Request for Council Action

Originator Community Development	Item Preliminary and Final Plat, Preliminary and Final Development Plan for a 420 Unit, six-story Apartment Building and Parking Structure	# 5.2A 1,2,3,4
Agenda Section HEARING/PUBLIC INPUT Development Business	By DLF 	Approved Date December 2, 2013

Case 2830FGHI-13

Request: F) Major Revision to Preliminary Development Plan
G) Final Development Plan for a 420 unit, six-story apartment building with attached parking structure
H) Preliminary Plat for BLOOMINGTON CENTRAL STATION 4TH ADDITION
I) Final Plat for BLOOMINGTON CENTRAL STATION 4th ADDITION

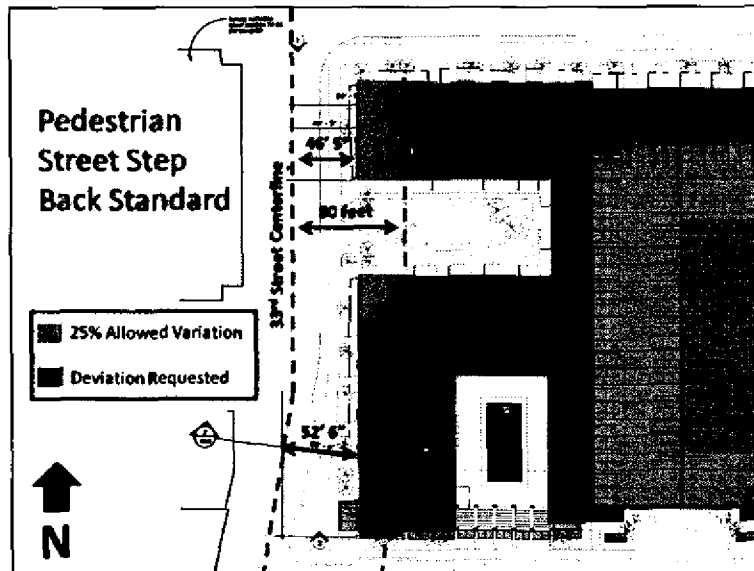
Code allows up to 25% of an individual block face to exceed the Pedestrian Street Step Back Standard, thus allowing roughly 93 feet of the building face to encroach into the step back area. The west face of the residential building has roughly 254 feet within the step back area, a deviation of 161 feet. The graphic below shows the area allowed to encroach by Code (orange), and the requested area of deviation (red). In the area of deviation, the building height is between 66 and 75 feet (due to taller parapets), whereas only heights between 46 feet and 54 feet would be allowed (depending on the curvature of the road), thus a deviation ranging from 13 feet to 29 feet in height on the west façade is requested.

To meet the Pedestrian Street Step Back Standards, the applicant would be required to remove approximately 9 or 10 units on the west side of the building. There are competing objectives in this area. On one hand, the Comprehensive Plan and HX-R zoning district calls for creating high residential densities near LRT stations. On the other hand, City height standards are designed to avoid canyon effects and shadowing from taller buildings. The distance between the proposed hotel tower and the apartment building wall is approximately 135 feet (see graphic below). Staff feels that the applicant is meeting the intent of the code due to the fairly wide distance between buildings and by incorporating courtyards areas to break up the length of solid building wall. In this case, flexibility is warranted to achieve the objective of adding residential density near LRT stations.
